ADDENDUM NO. 1

Clear Runway Visibility Zone and Relocate Fuel Tanks
North Central State Airport
Smithfield, Rhode Island

RHODE ISLAND AIRPORT CORPORATION

April 4, 2013

SHEET TITLE
SITE PLAN No. 3

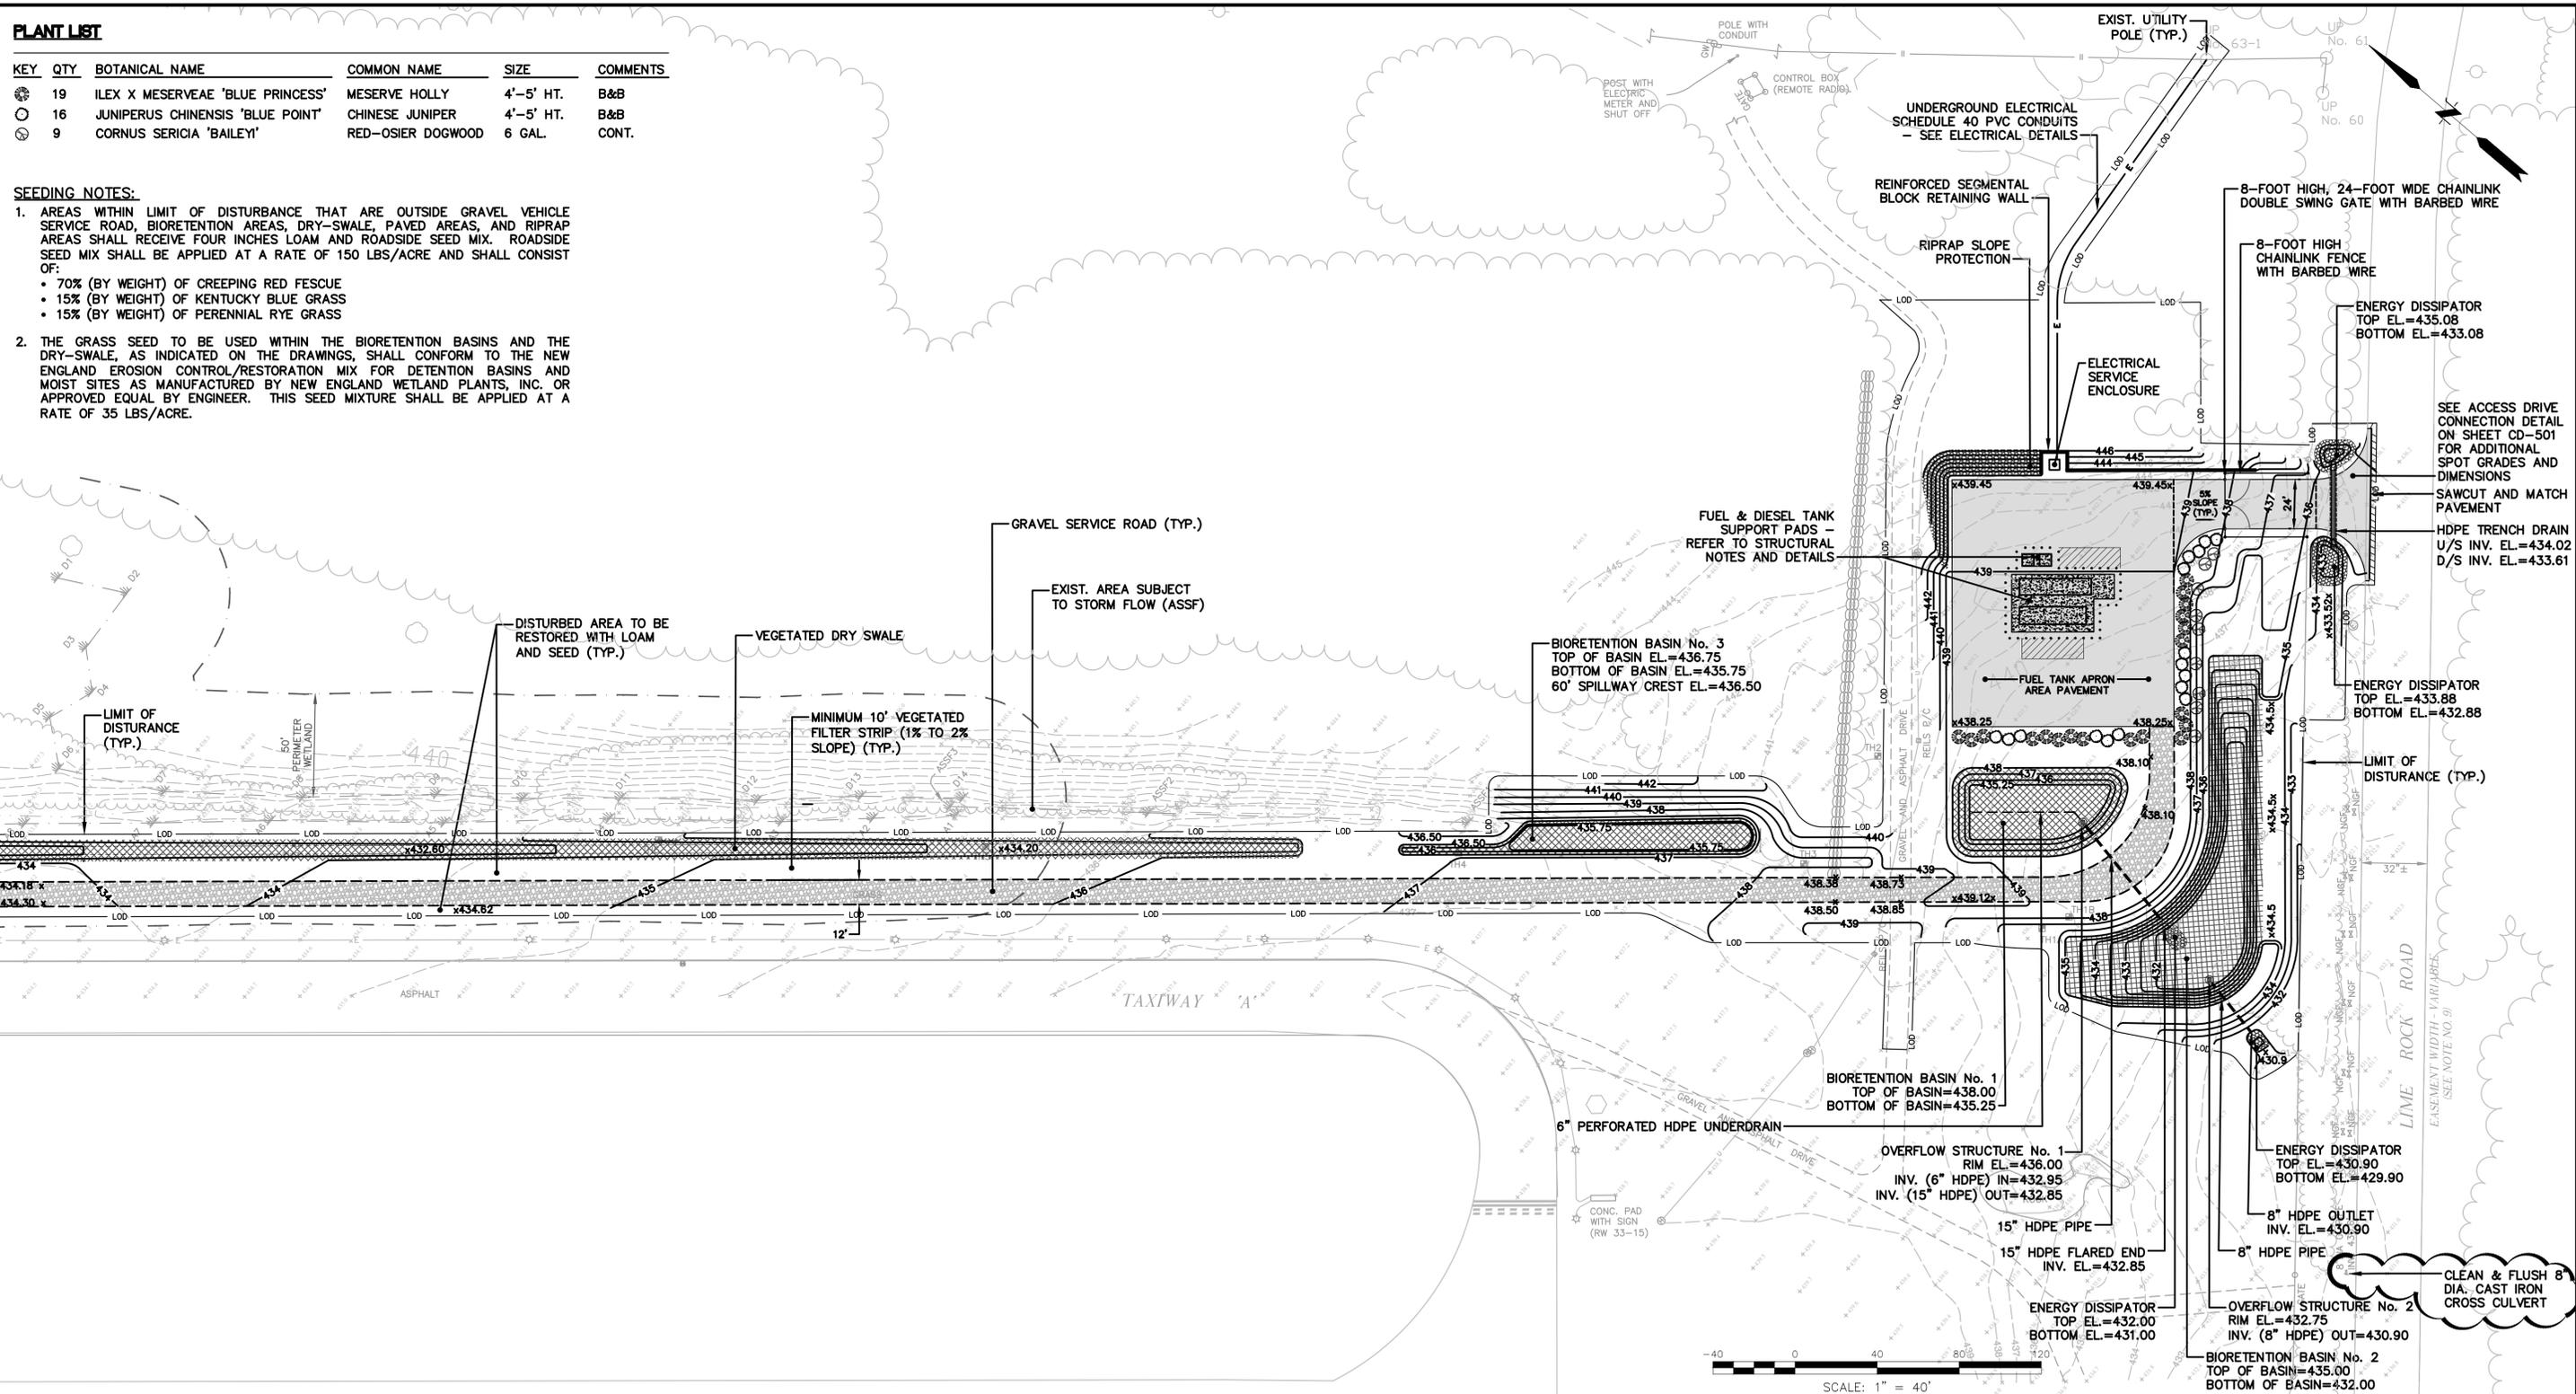
ADD "clean and flush 8" dia. cast iron cross culvert." Refer to attached FIGURE 3 Site Plan No. 3 sheet CS-110.

SHEET TITLE
STRUCTURAL NOTES AND DETAILS

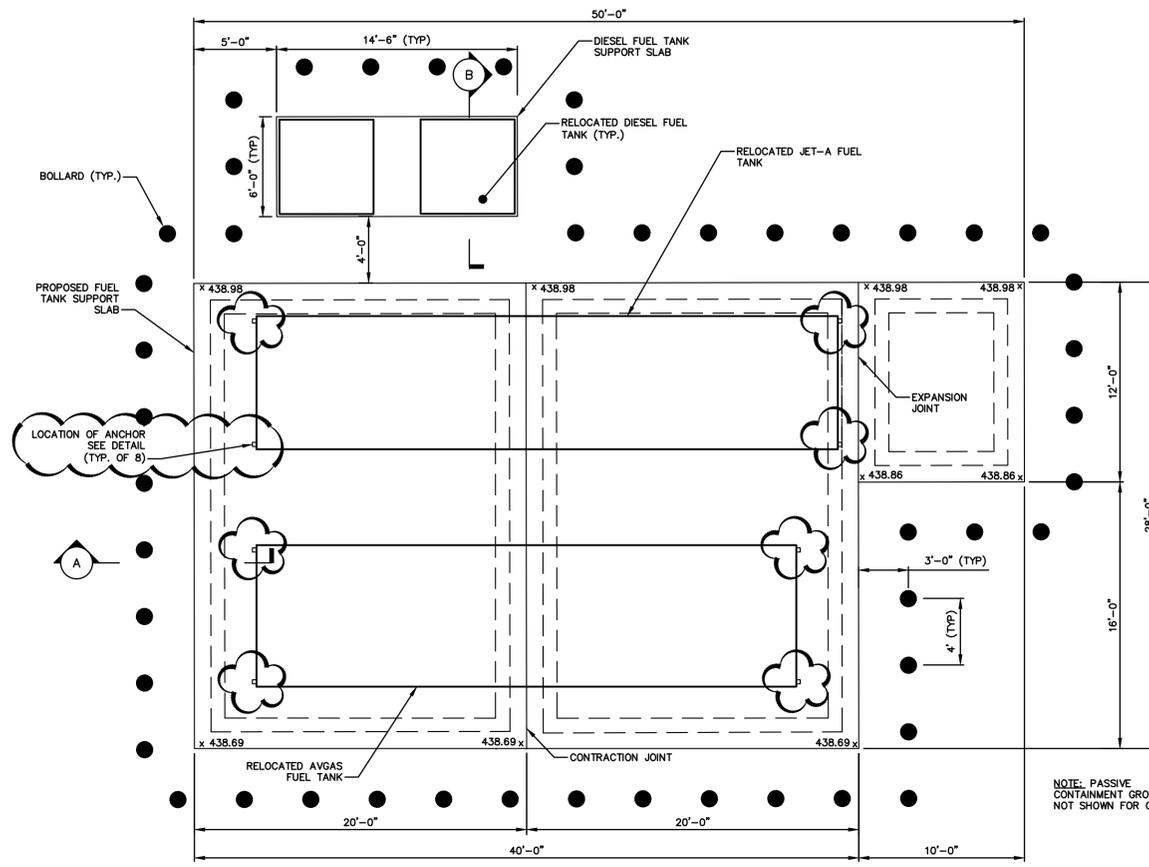
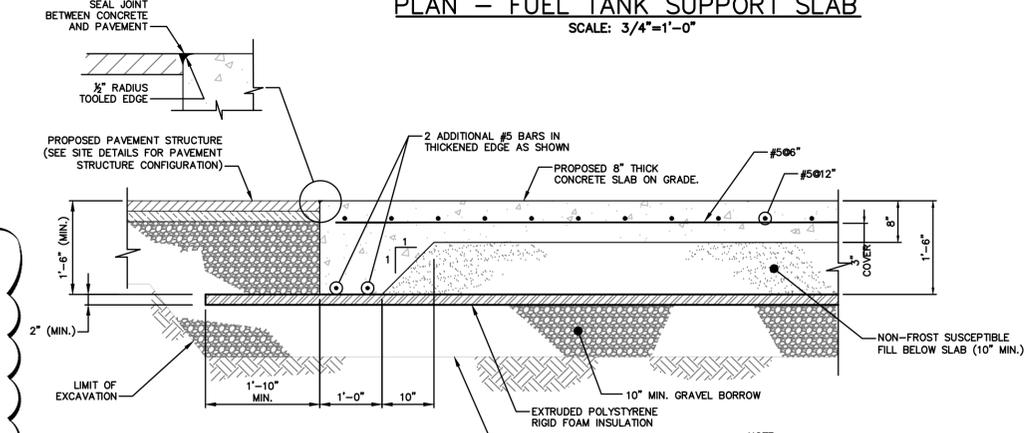
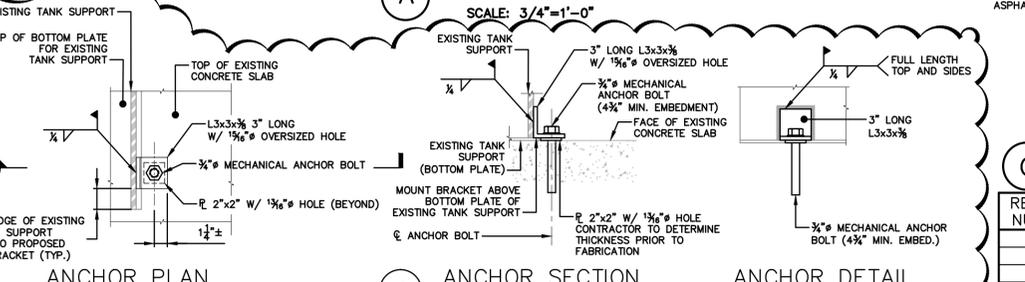
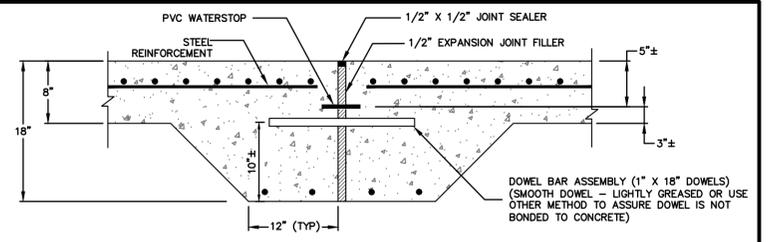
ADD Anchor Bolts note, Tank Anchors note, Welds note, Bracket Plan, Bracket Section, and bracket locations for AVGAS and Jet A fuel tanks. Refer to attached FIGURE 4 Structural Notes and Details sheet SA-501.

ANCHOR BOLTS:

- ANCHOR BOLTS SECURING TANKS TO THE CONCRETE SLAB SHALL BE HILTI KWIK BOLT 3 POST INSTALLED MECHANICAL ANCHORS OR APPROVED EQUAL.
 - DIAMETER: 3/4"
 - MIN. EMBEDMENT: 4 3/4"
- BOLT HOLES IN STEEL PLATES USED TO SECURE FUEL TANKS TO FACE OF CONCRETE SLAB SHALL BE BOLT DIAMETER PLUS 3/16".
- BOLT HOLES IN SPACERS SHALL BE BOLT DIAMETER PLUS 3/16".
- THE CONTRACTOR SHALL INSTALL ANCHOR BOLTS IN ACCORDANCE WITH THE MANUFACTURER'S WRITTEN INSTRUCTIONS.

TANK ANCHORS:

- THE STEEL ANGLES TO BE WELDED TO THE TANK SUPPORTS SHALL BE NEW, CLEAN, AND STRAIGHT.
- STEEL ANGLES SHALL COMPLY WITH ASTM A36.
- STEEL ANGLES SHALL RECEIVE A PRIMER COAT CONSISTING OF AN EPOXY PRIMER APPLIED AT A SPREADING RATE RECOMMENDED BY THE MANUFACTURER.

WELDS:

- ALL WELDING SHALL CONFORM TO THE AMERICAN WELDING SOCIETY D11-2010 STRUCTURAL WELDING CODE-STEEL.
- ALL FILLET WELDING SHALL BE A MINIMUM OF 1/4" WELD UNLESS NOTED OTHERWISE ON DRAWINGS.
- PROVIDE WELDER CERTIFICATIONS FOR REVIEW PRIOR TO PERFORMING THE WORK. WELDERS SHALL BE CERTIFIED IN ACCORDANCE WITH AWS D11.1-2010 STRUCTURAL WELDING CODE-STEEL.
- SELECT WELDING RODS ACCORDING TO AWS SPECIFICATIONS FOR METAL ALLOY WELDED.
- REMOVE ALL PAINT, DIRT OIL AND GREASE FROM THE SURFACES BEING WELDED.
- WELD CORNERS AND SEAMS CONTINUOUSLY.
- OBTAIN FUSION WITHOUT UNDERCUT OR OVERLAP.
- REMOVE WELDING FLUX IMMEDIATELY AND FINISH WELDS AND SURFACES SMOOTH AND BLENDED.
